## BOONE COUNTY, MISSOURI Request for Bid #: 05-28FEB11 – Chiller Installation

## ADDENDUM #5 - Issued February 25, 2011

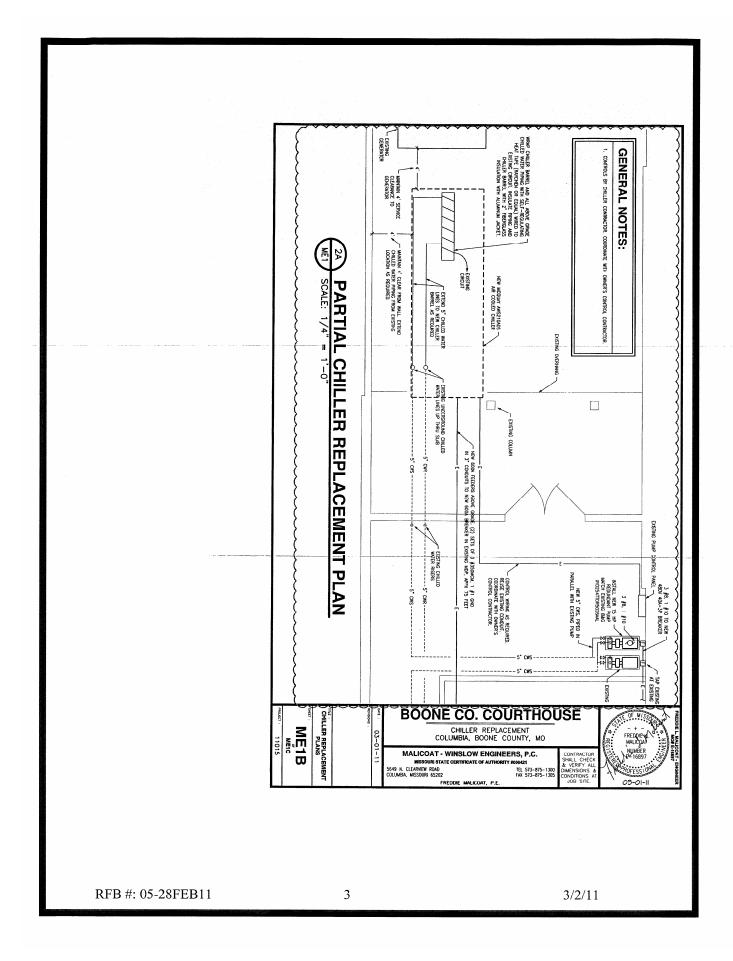
Single packaged air cooled chiller, nominal 200 tons, s to be installed. Chiller to be a McQuay AWS210ADS or equal from approved manufacturer. Chiler to be capable of producing 30 degree F LWT 40 degree F EWT at 480 GPM. Chiller to be sound insulated and have sound power rating less than 95 dba, sound pressure less than 64 dba at 30 feet. Chiller to be mounted on concrete pad with spring vibration isolation. Maximum length of chiller to be 250".

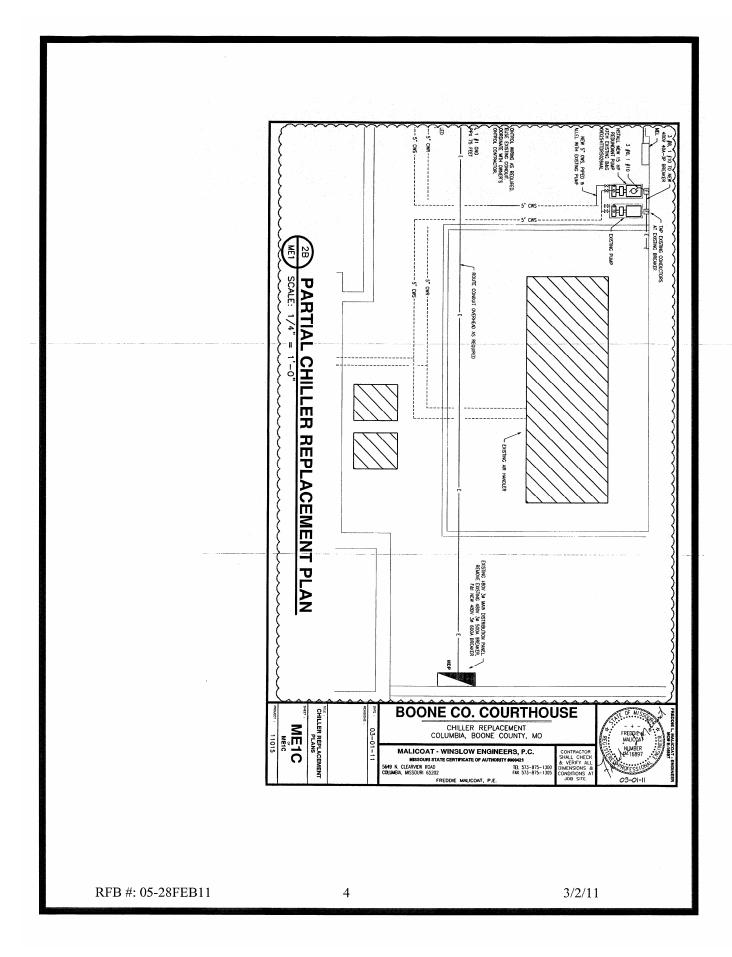
Heat exchanger to be shell and tube type, mounted outdoors, packaged underneath chiller. Heat Ecvhanger and outdoor chilled water piping to be wrapped with self regulating heat tape (Raychem or equal) and 2" fiberglass insulation with 0.010" thick embossed aluminum jacket.

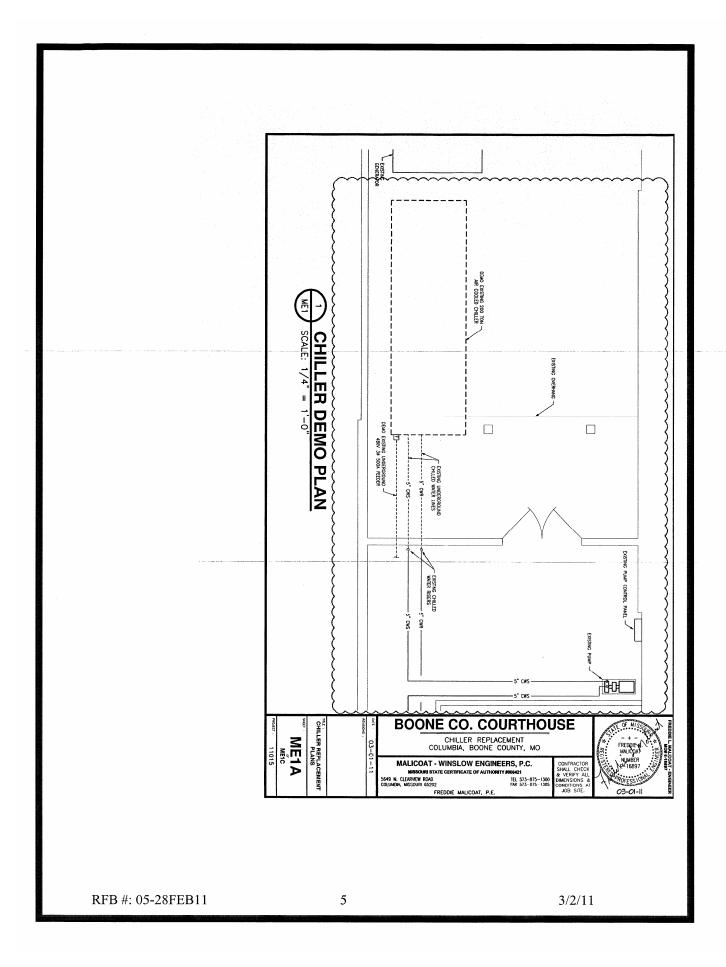
A new 480V 600A breaker is to be installed in the main distribution panel in place of the existing 500A breaker. New 600A feeders are to be routed overhead through the mechanical room to the new chiller.
